*The New Piper Aircraft, Inc.* 2926 Piper Drive Vero Beach, Florida, U.S.A. 32960

# SERVICE NO. 1026 BULLETIN

Distribution of Parker Hannifin Airborne Service Letter 48, "Inspection/Replacement of dry air pump flexible couplings".

Service Letter Number: 48

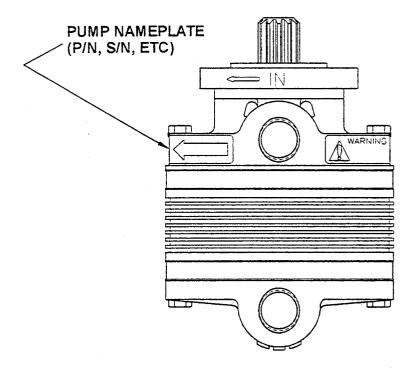
- 3) Once the flexible coupling assembly is removed from pump, separate the flexible coupling and drive shaft by inserting a screwdriver or similar tool between the two components. Refer to Figure 3.

FIGURE 2

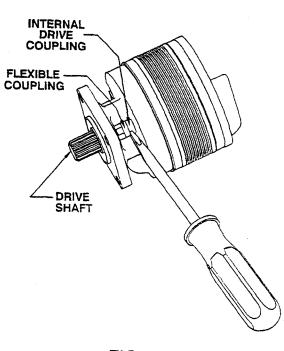
- 1) Remove dry air pump from engine accessory pad per instructions provided by the airframe manufacturer in the appropriate maintenance publication.
- 2) Insert a screwdriver or similar tool between the flexible coupling assembly (2-piece) and the pump's internal drive coupling. Remove the flexible coupling assembly from pump, taking care not to damage any of the eight drive pins. Refer to Figure 2.
